**NOTICE OF MEETING
PLANNING & ZONING COMMISSION
TUESDAY, MAY 5, 2026
T.W. "TURK" CANNADY – CEDAR HILL ROOM
CEDAR HILL GOVERNMENT CENTER
285 UPTOWN BLVD. – BLDG. 100
CEDAR HILL, TEXAS 75104
6:00 P.M.**

RE: Case No. FP-781-2026 (Final Plat – Milotte Margaret Estates, Lots 2R, 3R-1, and 3R-2, Block 1)

**LOTS 2R, 3R-1, AND 3R-2, BLOCK 1,
MILOTTE MARGARET ESTATES, REVISED,**

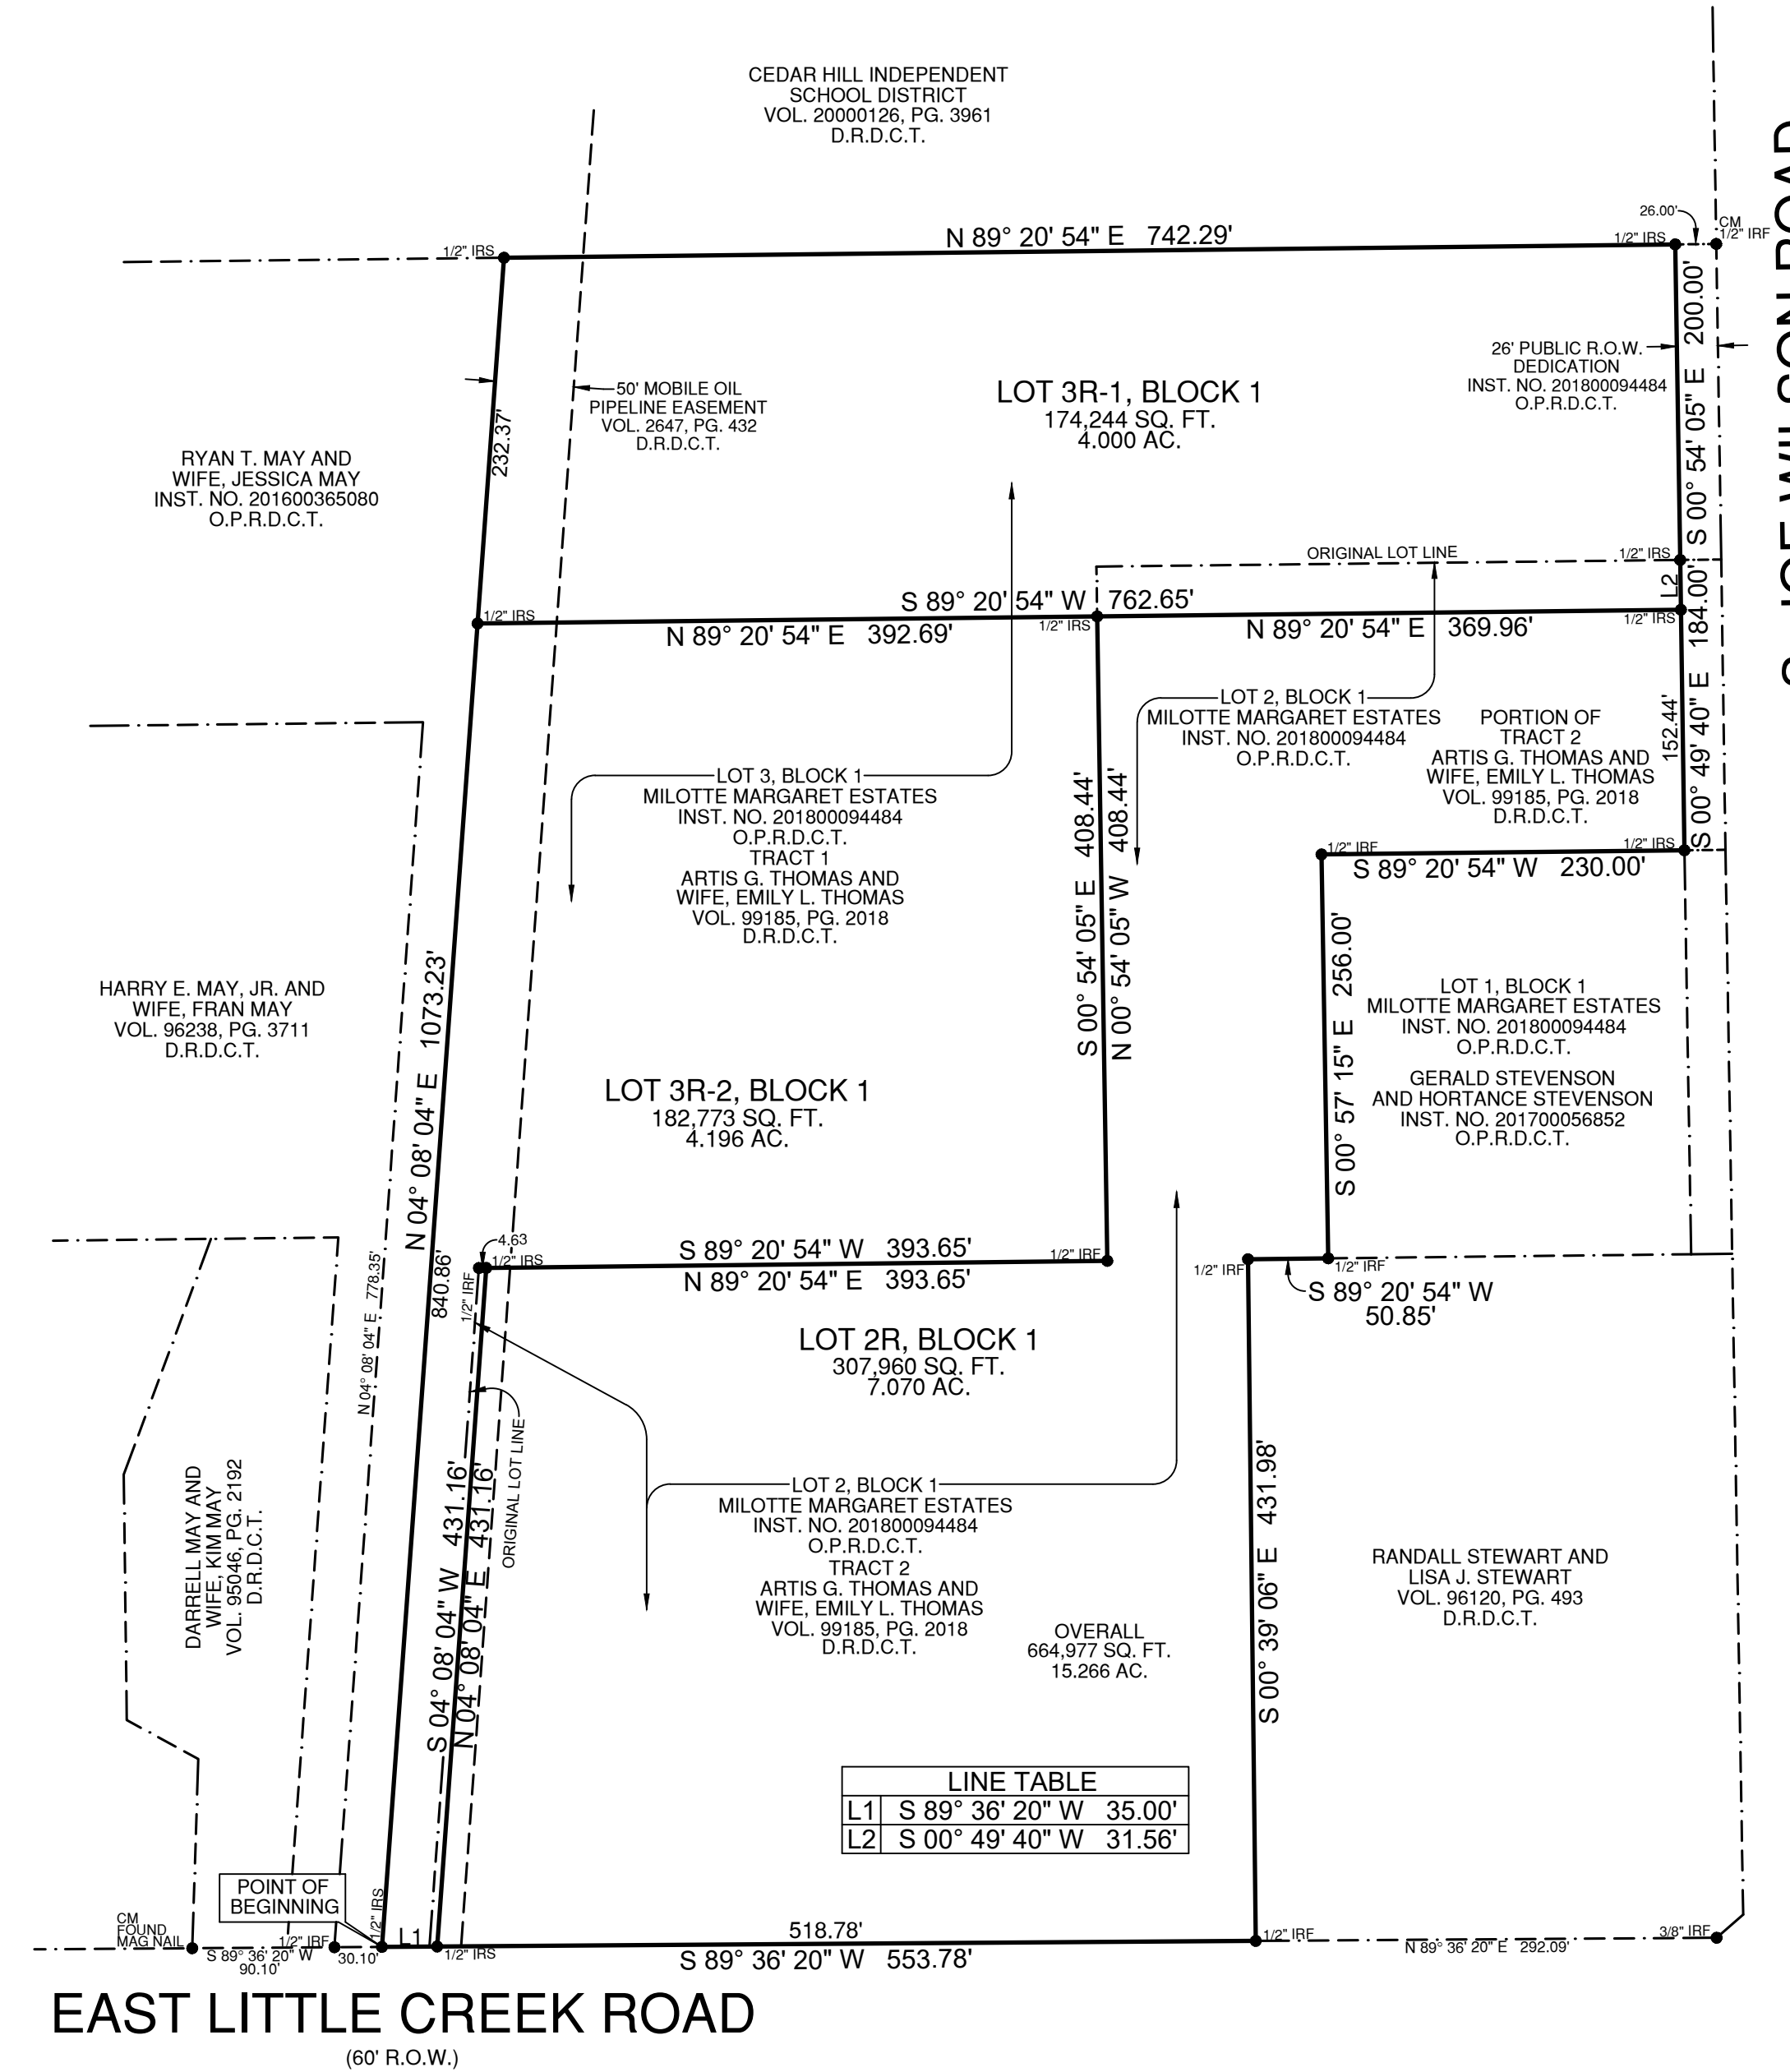
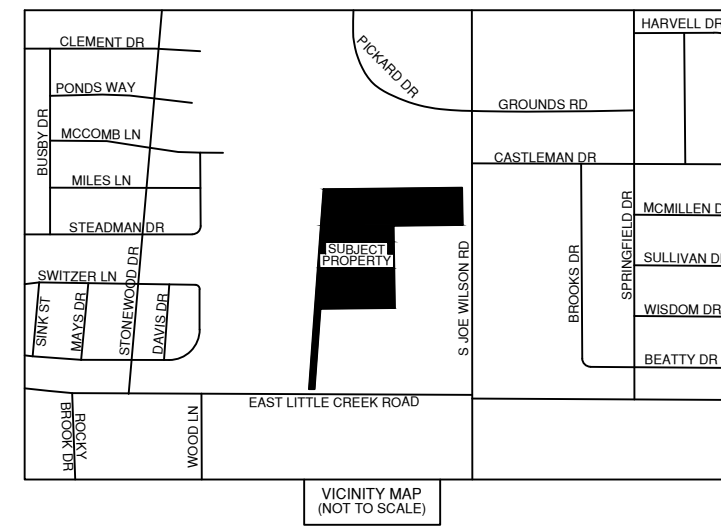
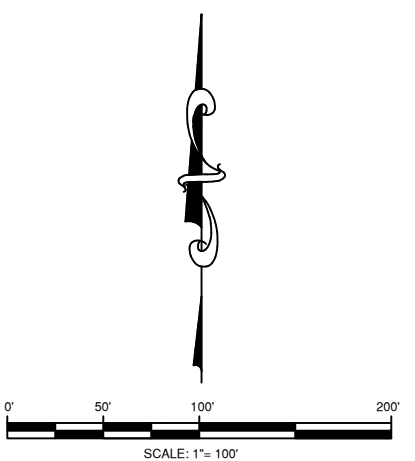
Planning Department	Code Citation
1. Provide an as-built survey showing existing conditions including but not limited to the following: <ul style="list-style-type: none"> • Existing on-site septic system showing the location of the tanks, manholes, spray fields and the underground lateral lines; • All existing structures, such as main house, detached garages and accessory structures, pools, fences, etc. • Pavement, driveways, patios, etc. • Provide general dimensions. 	
2. Add case no. FP-781-2026 underneath the Title Block.	
3. Add a note stating purpose of replat.	
4. Add the following note on the plat: “This replat does not attempt to amend or remove any

<p>covenants or restrictions.”</p>	
<p>5. Add the following note on the plat:</p> <p>“Selling a portion of this addition by metes and bounds is a violation of the Subdivision Regulations and State law and is subject to fines and/or the withholding of utilities and building permits.”</p>	<p>TLGC, Section 212.014</p>
<p>6. Add the following note on the plat:</p> <p>“Building setbacks shall comply with the Zoning Ordinance at the time of the Building Permit.”</p>	<p>Chapter 20, Section 20-11(b)(9) of the Subdivision Ordinance</p>
<p>7. For a replat, revise the Title Block as shown below:</p> <p style="text-align: center;">FINAL PLAT of LOT(S) _____, BLOCK(S) _____, OF THE _____ ADDITION CEDAR HILL, DALLAS COUNTY, TEXAS and being a REPLAT of Lot(s) _____, Block(s) _____ as previously filed in Volume _____, Page _____ of the plat records of Dallas County.</p>	<p>Chapter 20, Section 20-11(f) of the Subdivision Ordinance</p>

<p>8. Add the following City approval Block to the plat:</p> <p><i>Typical CITY APPROVAL BLOCK: PLACE THIS ON ALL COPIES OF THE FINAL PLAT</i></p> <div style="border: 1px solid black; padding: 10px;"> <p style="text-align: center;">CITY APPROVAL STATEMENT:</p> <p>Approved this _____ day of _____, 20____, by the City of Cedar Hill, Texas.</p> <p>_____</p> <p><i>Mayor of Cedar Hill, TX</i></p> <p>_____</p> <p><i>Planning & Zoning Commission Chairman of Cedar Hill, TX</i></p> <p>_____</p> <p><i>City Secretary of Cedar Hill, TX</i> Page ____ of ____</p> </div>	<p>Chapter 20, Section 20-11</p>
<p>9. Show and dimension the existing right-of-way of South Joe Wilson Rd. and East Little Creek Rd. Provide dimensions at each corner pin.</p>	<p>Chapter 20, Section 20-11(b)(2) of the Subdivision Regulations.</p>
<p>10. Label previous lot lines as “Existing Lot line to be abandoned by this plat”.</p>	
<p>11. Provide Northern and Easterlings for at least two corner pins</p>

for reference in city GIS system.	
12. Revise dates (year) on signature blocks.	
13. Remove word "revised" from the name of the plat.	
14. Revise Surveyor's Certificate to reference correct city (City of Cedar Hill).

15. Revise vicinity map to include Lot 2R.	
16. Relocate Line Table outside diagram.	
17. Revise plat to a larger scale (diagram should be larger).	
18. Remove owner's phone number from plat.

19. The proposed Lot 3R-2 will no longer have access to South Joe Wilson Road. Please note there is an existing 50-foot wide Mobil Oil Pipeline Easement along the west property line that takes up the entire flagpole area provided for the driveway access from East Little Creek Road into Lot 3R-2. Before this plat can be recorded, provide approval from the pipeline company allowing a driveway that meets city codes and standards to be fully constructed within their easement along the flagpole area. If they do not allow this, you can consider widening the flagpole area as long as you provide an as-built survey that shows the existing and proposed property lines, the existing house on Lot 2R and the existing septic system (including the spray field) so that staff can verify that the proper setbacks from the proposed property lines are still being accomplished.

Fire Department	Code Citation
1. 24 foot wide approved fire apparatus access road capable of supporting heaviest fire apparatus. When access road is a dead end, an approved fire apparatus turnaround shall be provided.	Appendix D IFC D102.1 & D103.4

Parks Department	Code Citation
1. Due to the size of the residential property, the applicant	Chapter 20,

<p>and/or property owner is required to pay a fee in lieu of park land dedication of \$700 per each lot. Additionally, \$500 per each dwelling (lot) is due for the park development fee. These fees will only apply to the newly created lot since parks fees were paid for the two current lots when they were previously platted. Therefore, the total amount due is \$1,200.</p>	<p>Section 20-42(c) & Section 20-43(a) of the Subdivision Regulations</p>
--	---
